JOST - Proposal for an amendment to R13 regarding ACV

ANNEX to Jost proposal (Figures)

Figure A: Point-to-point connection ECU Tractor (1) and ECU Trailer (9) when Fifth Wheel is closed

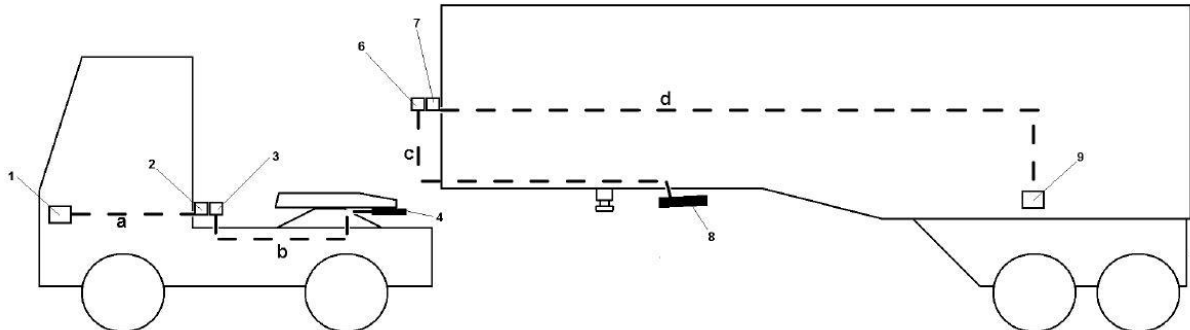
Amended text: The connection between the brake ECU (electronic control unit) on towing vehicle and trailer using ACV has to be point-to-point to ensure an explicit and unequivocal correlation. Active connections shall not have any bypasses or dead ends. Therefore tractors and trailer equipped with ACV shall both only have one singular socket according to ISO 7638:1997 (see Figure A to D: Pos 2, respectively Pos 7)
